Technical Note

CLIENT:	Extra MSA
PROJECT:	Proposed Erection of a Motorway Service Area, Land to the North of Junction 11 of the M62, Warrington
SUBJECT:	Groundwater Technical Note in response to EA letter dated 14 Feb 2020 SO/2019/119672/03-L01
JOB NO.:	SH11739
DATE:	20 March 2020
PREPARED BY:	L Ballarini: Service Area Lead – hydrogeology and hydrology

Section 2 - 2
(Vertical Exaggeration x1.00)

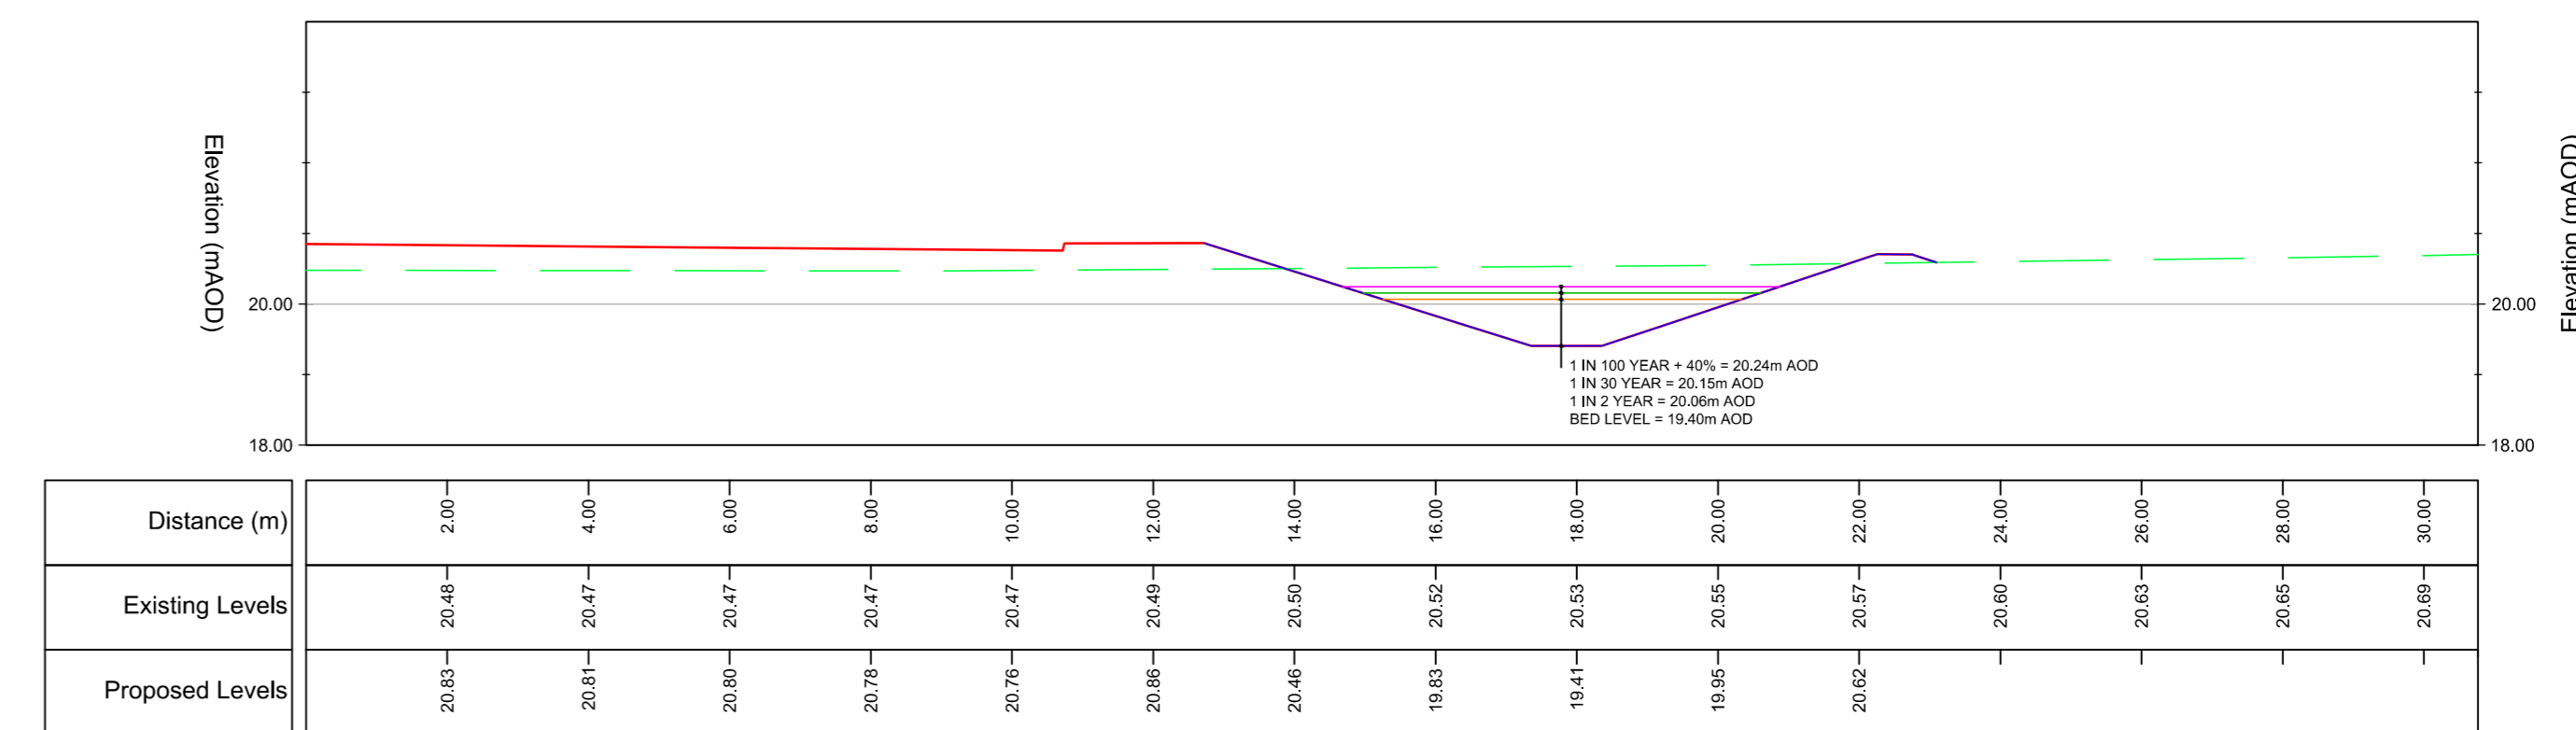
EA comment: [Provide information on] finished floor level data including expected level of brook.

Section 3.6 of the flood risk assessment details the design of the watercourse and, to clarify the indicative water depths expected within the proposed channel, we attach an additional drawing, SH11739-064 titled 'Silver Lane Brook Watercourse Sections'. This drawing details the estimated water level depths based on a Mannings channel roughness coefficient of 0.04 and 0.08 and shows the water depth for the estimated 1 in 100-year storm event plus 40% climate change discharge rate from the restored landfill site. This shows water depth to be well within the channel's capacity for both roughness coefficients, including a freeboard allowance.
